RESOLUTION OF THE LOCAL PLANNING AGENCY
THE TOWN OF FORT MYERS BEACH, FLORIDA
RESOLUTION NUMBER 2013-015
REZ2013-0001 – Houseboat, LLC Rezoning

MEMORANDUM

Re: 440 Old San Carlos Blvd – REZ2013-0001, SEZ2013-0005, VAR2013-0006

RE: REZ2013-0001; SEZ2013-0005; and Variances - Houseboat
(formerly Matanzas CPD)

EXHIBIT A
 MATANZAS
REDUCED BUFFER EXHIBIT
 JOHN RICHARD
 FORT MYERS BEACH, FL
 SOURCE: TDM, 12/13

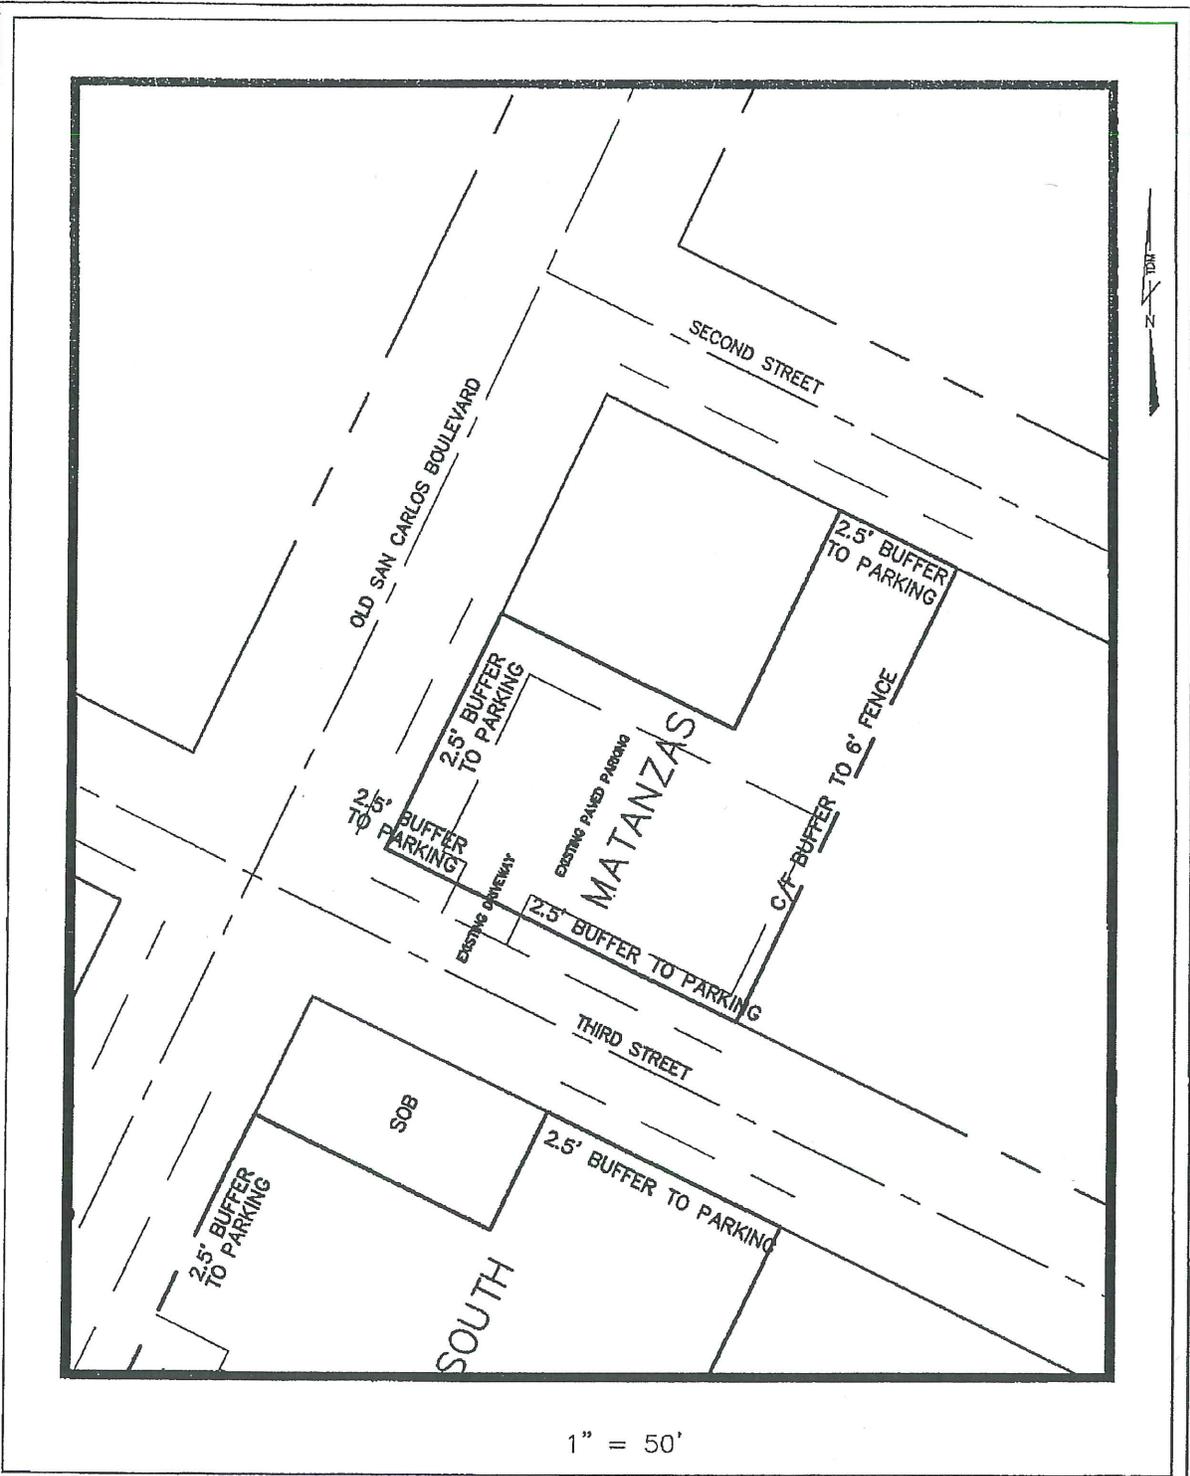
From Staff's estimation, the additional variances numbered 3, 4, and 5 are essentially to allow the existing conditions of the subject property to remain and not be rendered nonconforming by the act of rezoning the property from CPD to DOWNTOWN. Upon initial review, it appears that granting the requests to maintain a status quo condition is a reasonable action. However, one must remember that variance approvals run with the land – meaning that any approvals granted to permit and allow for existing conditions will remain in effect at the time of redevelopment. Furthermore, at the time of redevelopment the Town has its best opportunity to bring those properties inconsistent with the Land Development Code and the Comprehensive Plan into compliance.

Staff does agree with the applicant, however, that the size and scope of the buffers required (15' for a ROW buffer and 15' with a wall or 30' without a wall between the subject property and the adjacent residential use) by these code sections could be considered excessive and inconsistent with the intent of a vibrant, mixed use downtown core area encouraged by the Comprehensive Plan. As stated in the Staff report that was written in preparation for the November LPA hearing, Staff understands that a 15' foot buffer on an existing site not currently under development order may prove to be a burdensome requirement. However, the code does encourage landscape buffers as a way to shield parking lots from view and the pedestrian experience (see also Section 34-2022(c)). Staff would suggest that conditioning an approval to allow for a reduced size and scope of buffering would be a compromise equally agreeable to both the Town and the applicant. Therefore Staff suggests, as an alternative, that instead of a 15' wide buffer, the applicant will install a 5' buffer with the same number of shrubs and trees. This would be consistent with buffer deviations approved at 2301 Estero and similar to the planting requirements from the Seasonal Parking lot provisions.

1. The applicant shall install a Type D buffer in compliance with the all provisions of Table 10-9 except that where the width is reduced from 15' to 5', the applicant shall nevertheless install the same number of plantings that would be required for the 15' buffer.
2. Applicant may utilize the parking dimensions described in variance request #6, however, at the time of redevelopment or the application of a building permit for the subject property, the parking space dimensions must come into compliance with all provisions of Section 34-2016.

EXHIBIT A
MATANZAS
PARKING LAYOUT-
 JOHN RICHARD
 FORT MYERS BEACH, FL
 SOURCE: TDM, 12/13

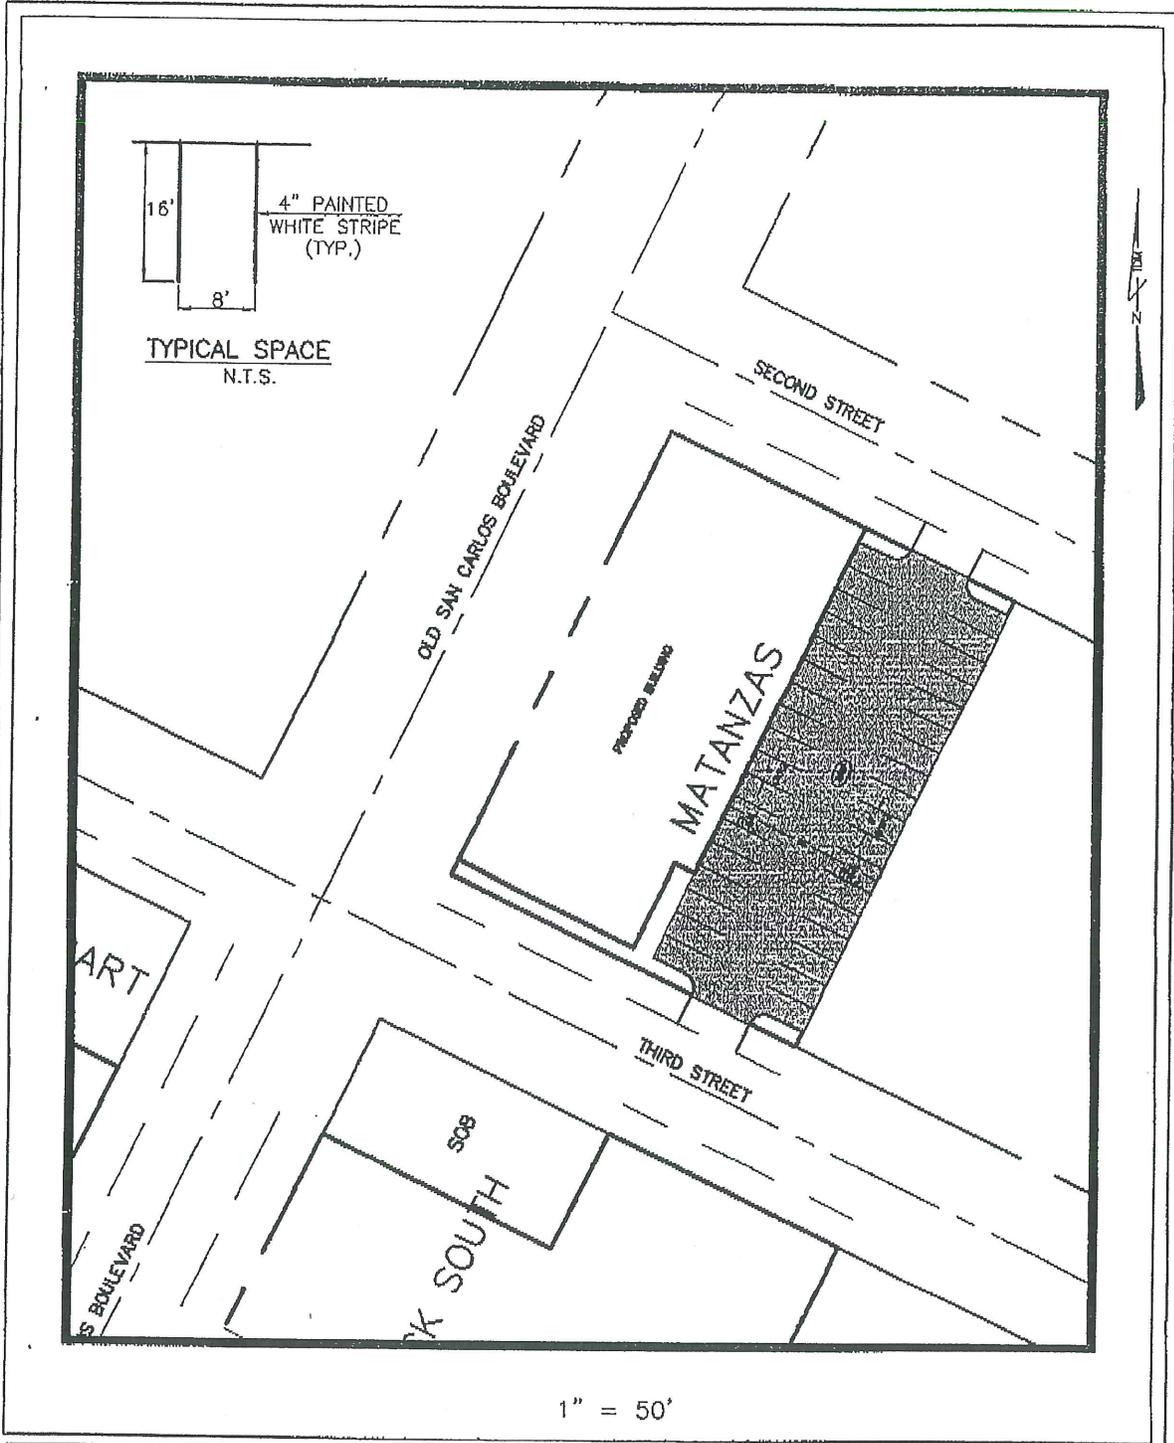
Variance #6 is a request to allow parking space and parking aisle dimensions that are smaller and narrower than code allows. Currently Section 34-2016 defines a minimum parking space as 8.5'x18' or 8.5'x20' and parking aisles between 11' to 22' wide depending on the specific layout of the lot. Similar to the discussion regarding buffers in the previous paragraphs, Staff understands the desire of the property owner to have the existing conditions be considered compliant. The

problem is that when its time to redevelop, the subject property will no longer have to comply with standards that its neighboring properties have been held to, and for what reason? The applicant has not provided any justification for allowing a reduction in parking dimensions. Furthermore, an 8x16 parking space with a one-way drive aisle is a very narrow space to navigate and with the seasonal influx of drivers unfamiliar to the roads and parking lots of the island, Staff is concerned about the safety ramifications of supporting this request.

Staff would propose a compromise on this particular request that the applicant utilize the dimensions laid out in request #6 until the time of redevelopment, at which time they would be required to install a new parking lot that meets buffer requirements and parking lot dimensions set forth in Sec. 34-2016.

a. Angle	Parking Dim.	One-Way	Two-Way
b. 45°	8' x 16'	10'	20'
c. 60°	8' x 16'	12'	20'
d. 75°	8' x 16'	15'	20'
e. 90°	8' x 16'	18'	20'

APPROVAL WITH CONDITIONS
7. Section 34-622 (b) and 34-3131 from visibility triangle for Second and Third Streets to allow reduced triangle as set forth in sketch - **DENIAL**
